CITY OF ALBUQUERQUE

February 9, 2024

**RE: Rio Grande Apartments
2211 Rio Grande Blvd. NW
Grading and Drainage Plans
Engineer's Stamp Date: 01/22/24
Hydrology File: H12D024**

Based upon the information provided in your submittal received 02/02/2024, the Grading & Drainage Plans **are not** approved for Building Permit, Grading Permit and SO-19 Permit. The following comments need to be addressed for approval of the above referenced project:

SHEET C-101

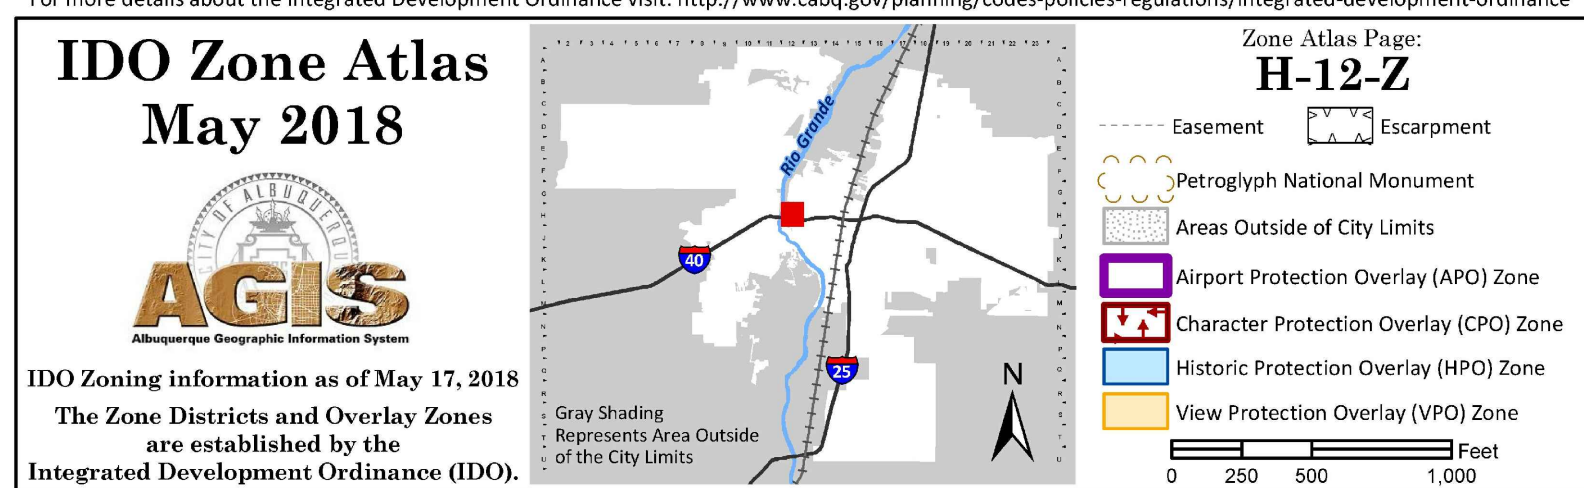
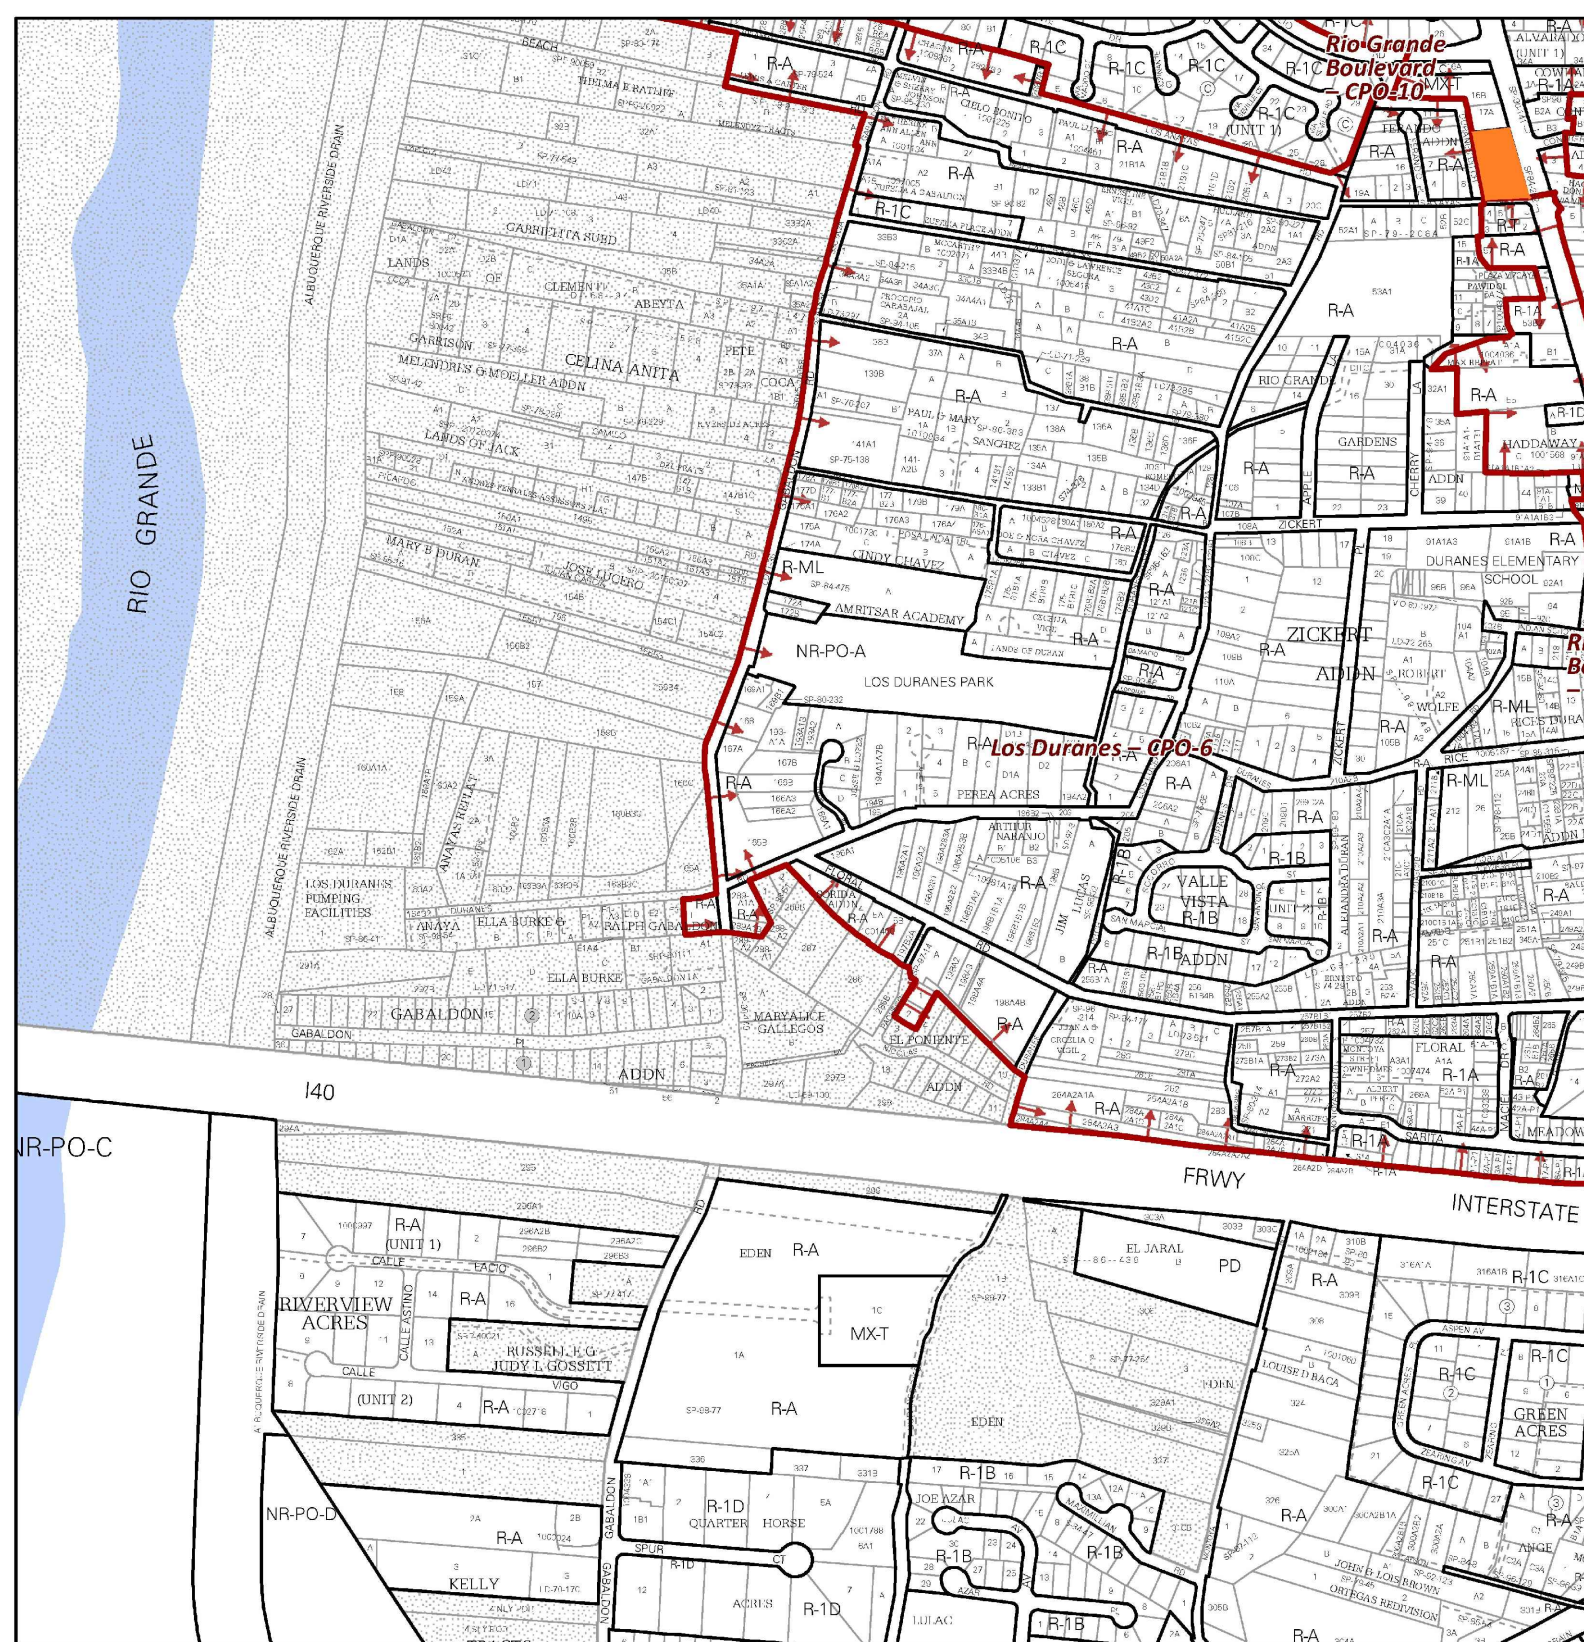
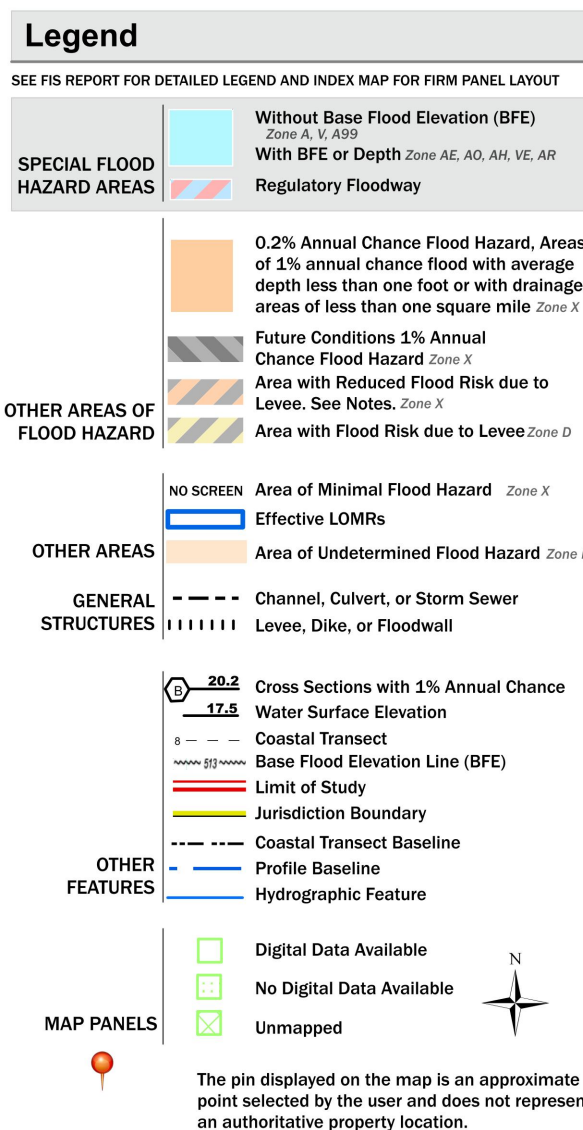
1. Please provide a legal Description of the property.
2. Existing Conditions. This site is in FEMA's Zone X Protected by Levee. (please fix note #9 of the General Notes as well) Also, the site is relatively flat and does not drain. There are also no railroad tracks anywhere near this site. Please fix the Existing Conditions.

A1 CONCEPTUAL SITE GRADING AND DRAINAGE PLAN
SCALE: 1"=20'

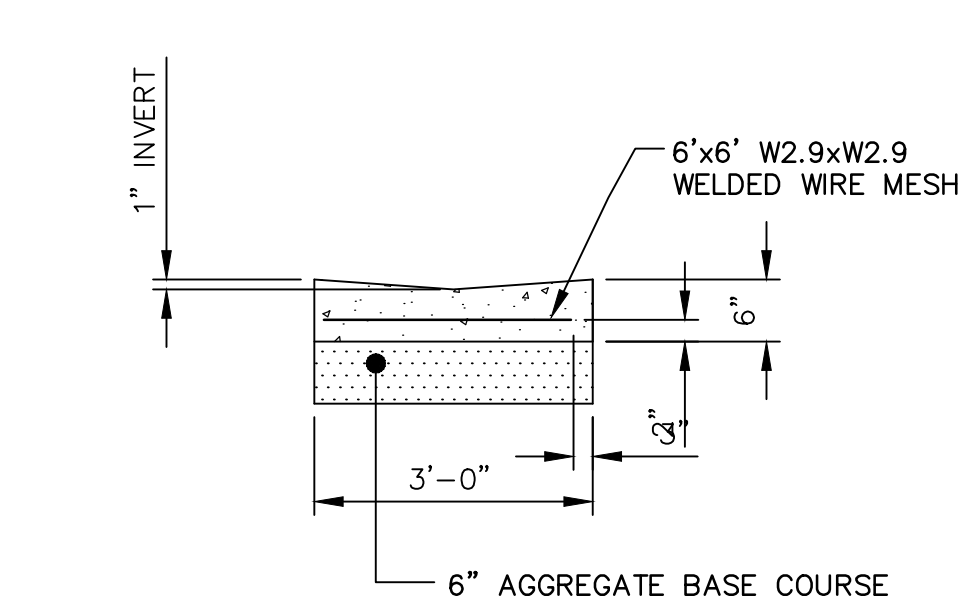
6. It is difficult to tell what is being installed since all the line work both existing and proposed is the same. Please change. Also the edge of roadway on Los Anayas Rd should only be a single line since there is no curb & gutter.

7. Please verify with Transportation. Along Los Anayas Road, this project will be responsible to install sidewalk along with curb & Gutter per the IDO.

8. Please remove Conceptual for the title of the Grading Plan.
9. Please provide a cross section for the retaining wall along the west property line showing proposed retaining walls, property/ROW lines, existing and proposed grades. In accordance with DPM, grading and wall construction near the property line may not endanger adjacent property or constrain its use. Please make sure that the footer for the wall stays within the project's property. Please provide this section on this Sheet.

10. Please move the cross section of the retention pond from Sheet C-501 to this Sheet. Also please refer to comments under Sheet C-501 for corrections to this cross section.

11. Key Note 8 should refer to City of Albuquerque standard detail No. 2236 – Sidewalk Culvert with Steel Plate Top.
12. Please provide invert information for the sidewalk culvert both at the retention pond and at the curb.

13. Please identify all underground utilities shown within the streets.

A3 WATER HARVEST CROSS SECTION A-A - POND A
SCALE: NOT TO SCALE

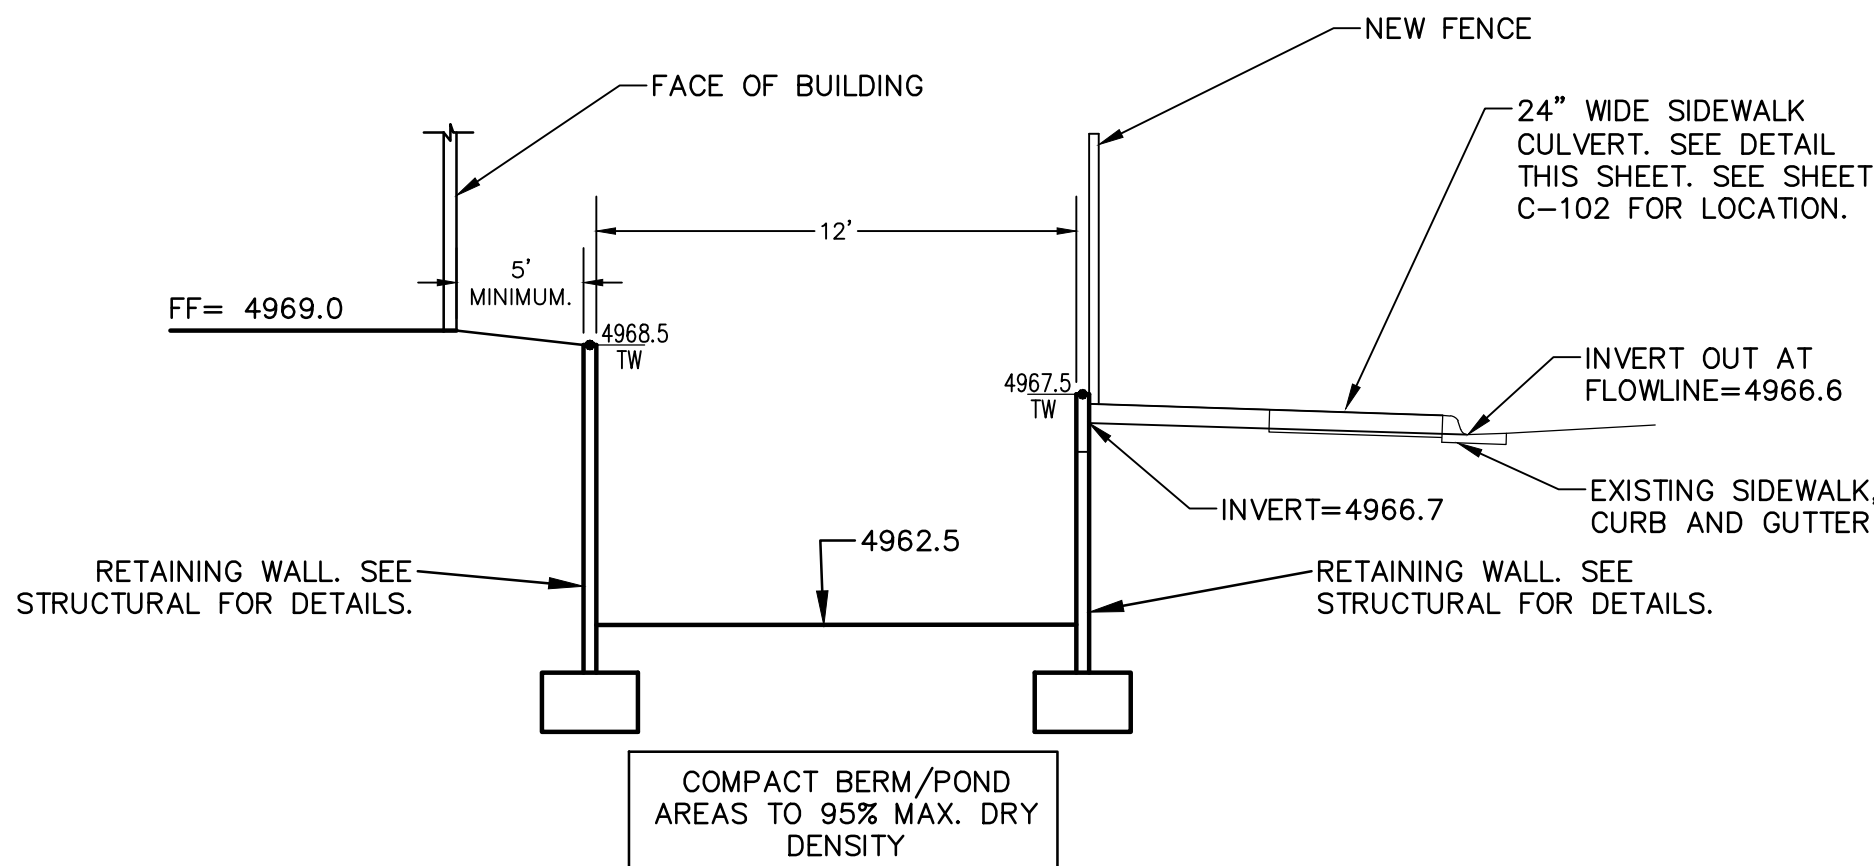
14. In the cross section, please showing property/ROW lines and add a note stating that the contractor shall waterproof the proposed retaining wall below the 100-yr 10 day water surface elevation of XXX per City standards. In accordance with DPM, grading and wall construction near the property line may not endanger adjacent property or constrain its use. Please make sure that the footer for the wall stays within the project's property. Also move this onto the Grading Plan per Comment #10.
